**THE CLOUD HOUSE AT  
20 & 20A VICARS ROAD NW5 4NL:

PROPOSAL FOR MINOR  
AMENDMENTS TO THE SCHEME  
SINCE PLANNING PERMISSION  
WAS GRANTED ON 13<sup>TH</sup> JULY 2022**

**Emily Kennedy & Peter Morris – and on behalf of Khin Thuzar Kyi  
OCTOBER 2022**

Illustration 3: Showing the metal frames which will support a decorative barrel-vaulted metal roof, with a standard waterproofed flat pitched roof hidden underneath  
October 2022

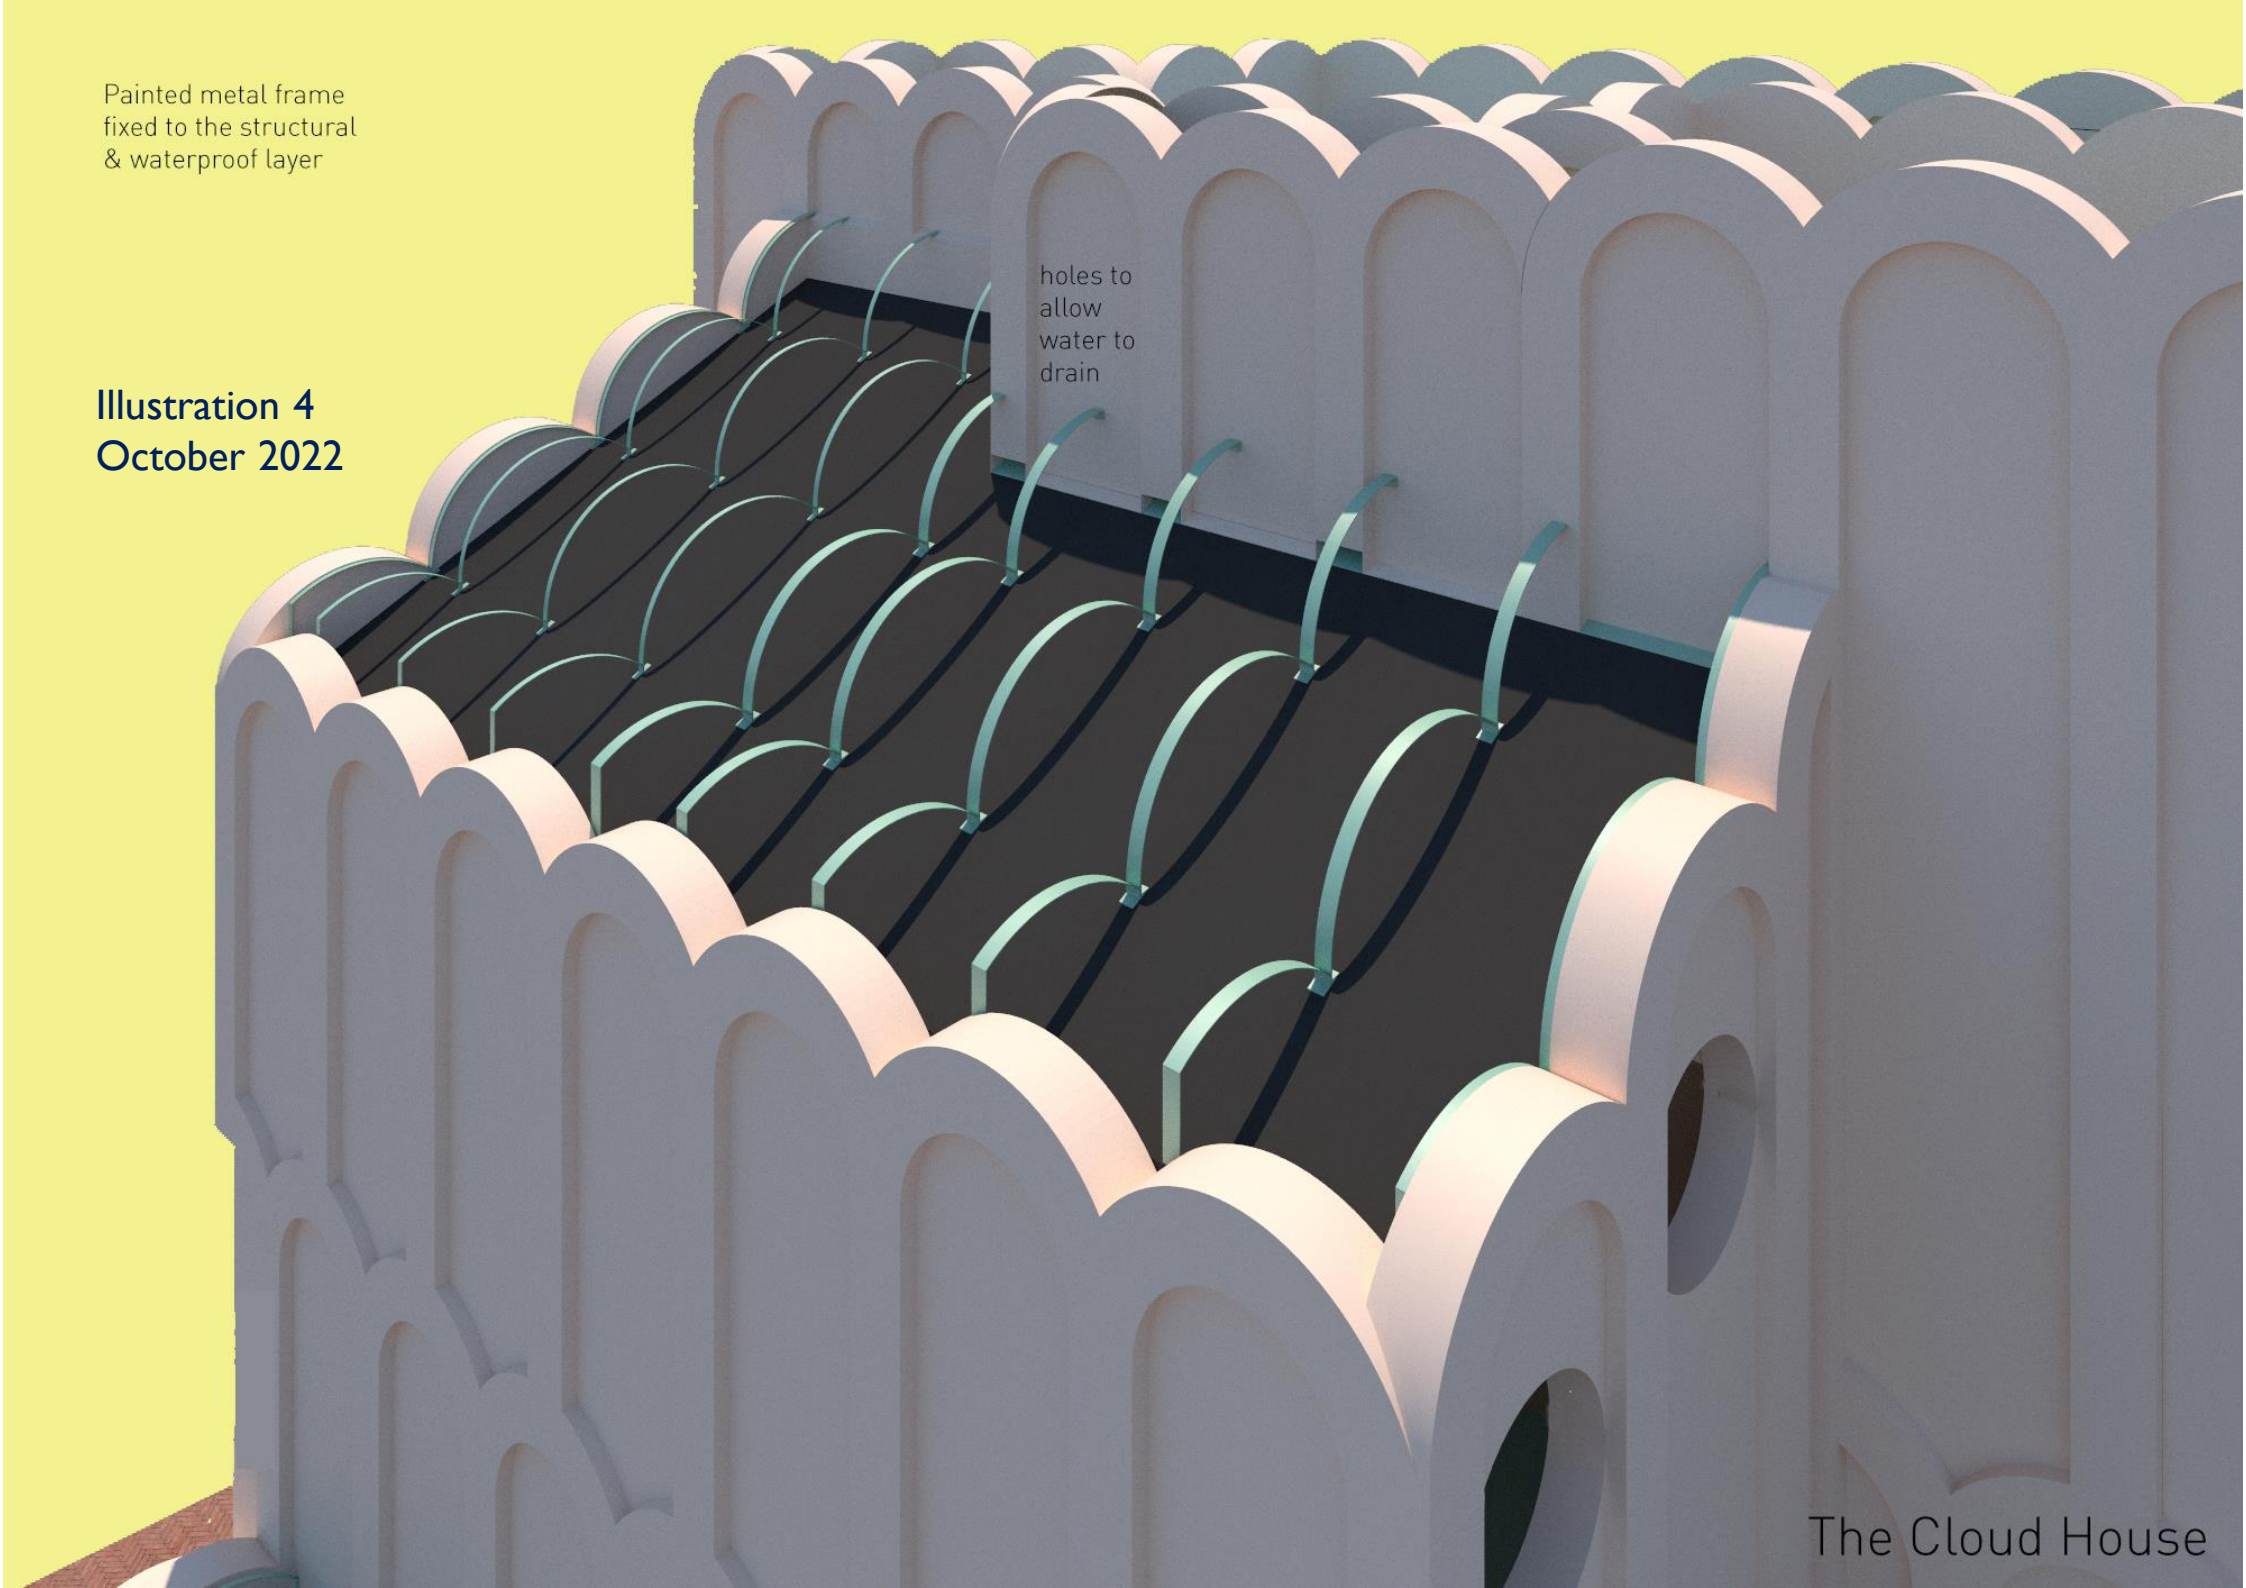
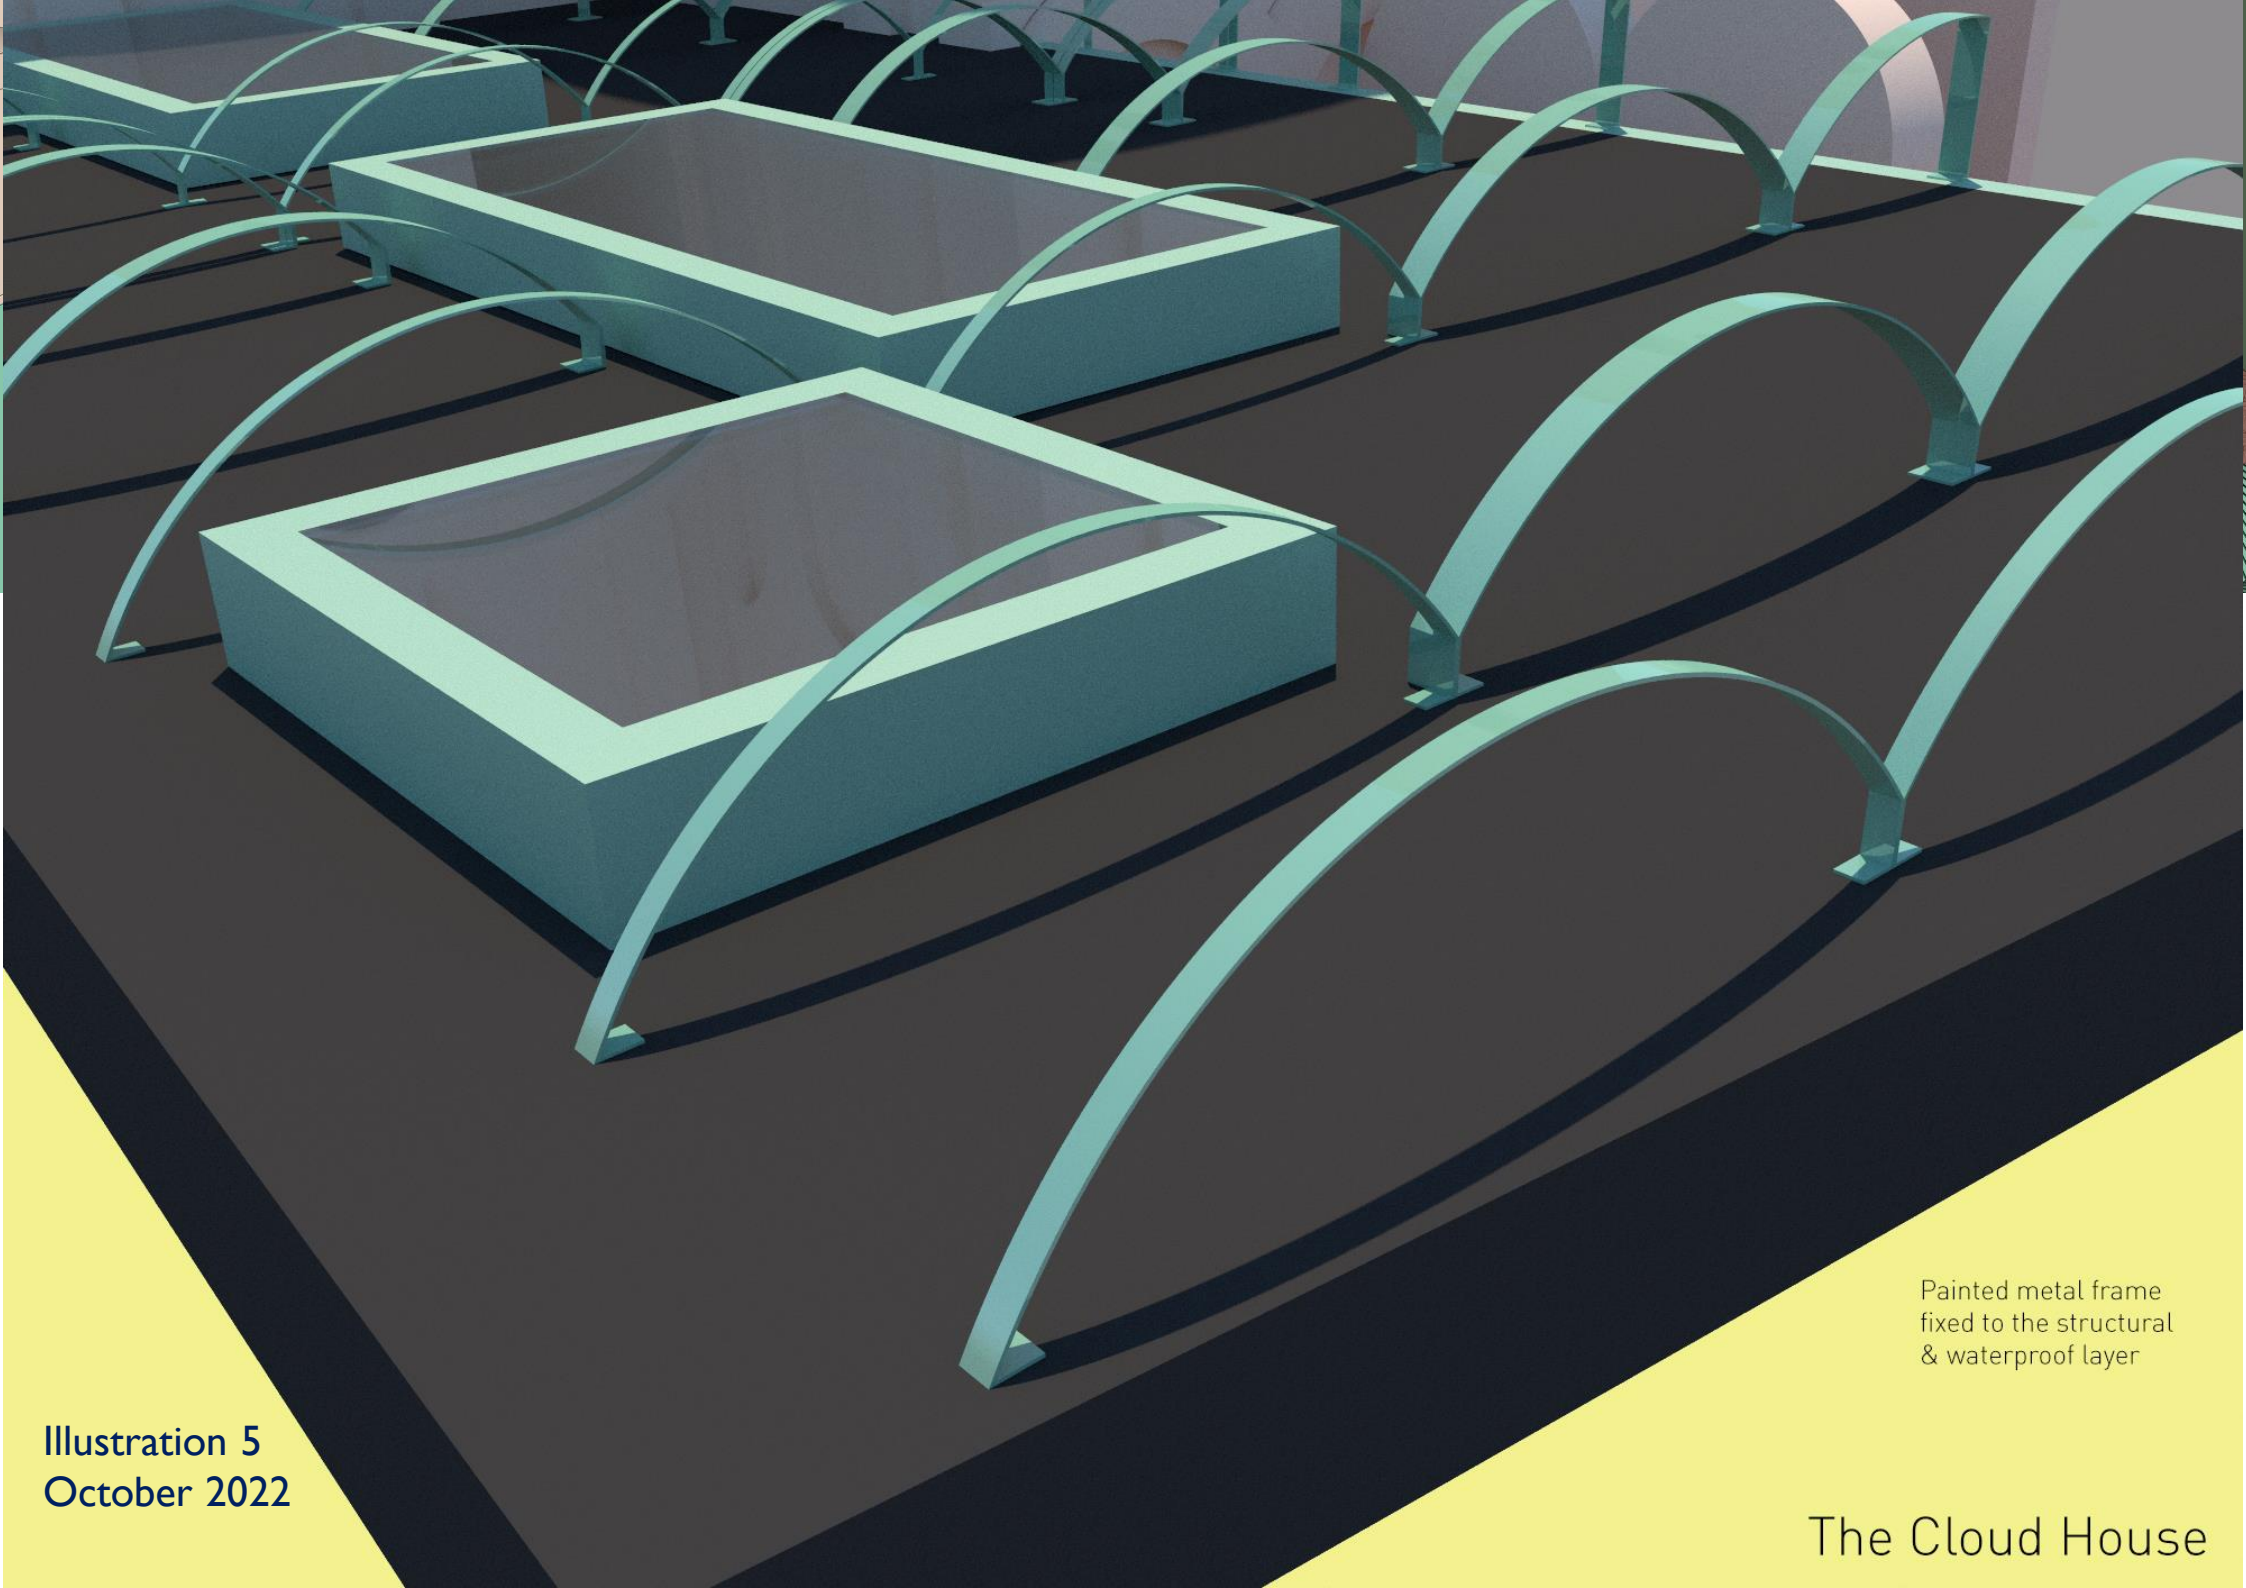
## **8) A CHANGE TO THE SURFACE MATERIAL OF THE BARREL-VAULTED ROOFS ON THE GROUND FLOOR OF 20A, SWAPPING FROM SEDUM TO A HIGH QUALITY PALE GREEN METAL ROOF**

REASON: Unfortunately, we have been advised by experts that our plan to cover the barrel-vaulted roofs on the ground floor of 20A with sedum is not going to work. There are three issues: 1) The sedum can't be planted on a slope of more than 15 degrees; 2) The whole area won't get enough sunlight for the sedum to grow, due to it being surrounded by tall buildings; and 3) Even with very good drainage, the areas between the curves will collect water, which will kill the sedum. Given the high likelihood of the sedum failing, and looking very ugly very quickly, it is the architect's view that it would be better to change the surface material of the barrel-vaulted roofs on the ground floor to the same pale green metal that's already been approved for the barrel-vaulted roofs on the top floor of 20A, so the two areas match.

IMPACT: The metal used for the roof will be Falzonal Pale Turquoise (please see attached information sheet), which is the same colour as the window frames, doors and all exterior metalwork across the whole Cloud House. It is a very high quality product and the plan is for it to be installed by Roles Broderick, a leading company who have created metal roofs for many award-winning buildings. The barrel-vaulted metal roofs will be purely decorative, and will be permeable, so that water can find its way through to the flat waterproofed pitched roofs below, both on the second floor and on the ground floor. Illustrations 3-5 on the following pages show how the barrel-vaulted roofs will be attached to the pitched roofs hidden below.
